Monthly Specification Update

Intel® Server Board S5520UR

Intel Order Number E69054-001

April 2009

Figure 1. Removing the Heatsink

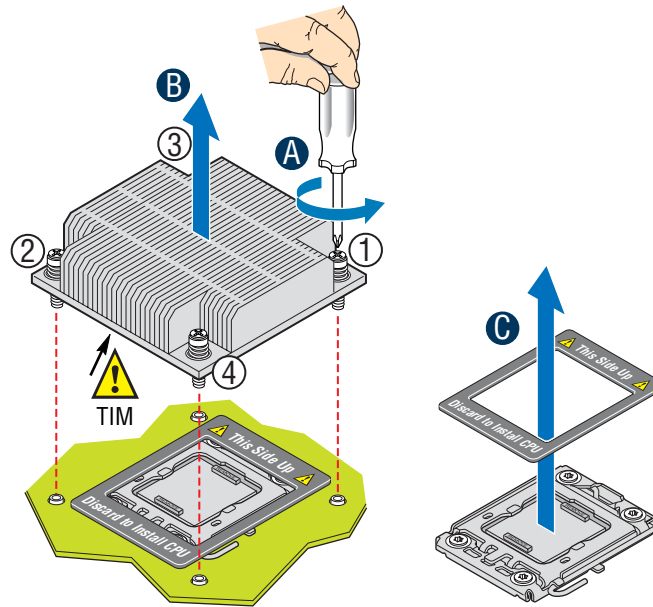
1. Proper Heatsink Installation and Removal Instructions are missing from Service Guide

- Problem:** The current documentation does not properly describe the installation and removal of the heatsink. Careful insertion and removal of the heatsink is required to prevent damage to the heatsink screws or backplate.
- Implication:** There is a possibility of damage to the heatsink if proper steps are not followed.
- Status:** Corrections incorporated into the latest version of the following Service Guides:
- Intel® Server System SR1600 Service Guide (Intel Order Number: E52880-003)
 - Intel® Server System SR1625 Service Guide (Intel Order Number: E52881-003)
 - Intel® Server System SR2600/SR2625 Service Guide (Intel Order Number: E51243-003)
- Workaround:** Perform the steps outlined below for installation and removal of the heatsink to avoid damage.

1. Loosen the four captive screws on the heatsink corners in a diagonal manner according to the numbers shown in **Error! Reference source not found.** as follows:
 - Starting with the screw at location 1, loosen it by giving it **two rotations** in the anticlockwise direction and stop. (**IMPORTANT:** Do not fully loosen.)
 - Proceed to the screw at location 2 and loosen it by giving it two rotations and stop.
 - Loosen screws at locations 3 and 4 by giving each screw two rotations and then stop.
 - Repeat steps 1a through 1c by giving each screw two rotations each time until all screws are loosened.
2. Do one of the following:
 - If removing the heatsink for the first time, do the following:
 - i. Lift the heatsink from the board.
 - ii. Remove and discard the spacer (see letter “C” in **Error! Reference source not found.**).

- If a processor is already installed, do the following:
 - i. Twist the heatsink slightly to break the seal between the heatsink and the processor.
 - ii. Lift the heatsink from the processor. If it does not pull up easily, twist the heatsink again. Do not force the heatsink from the processor. Doing so could damage the processor.
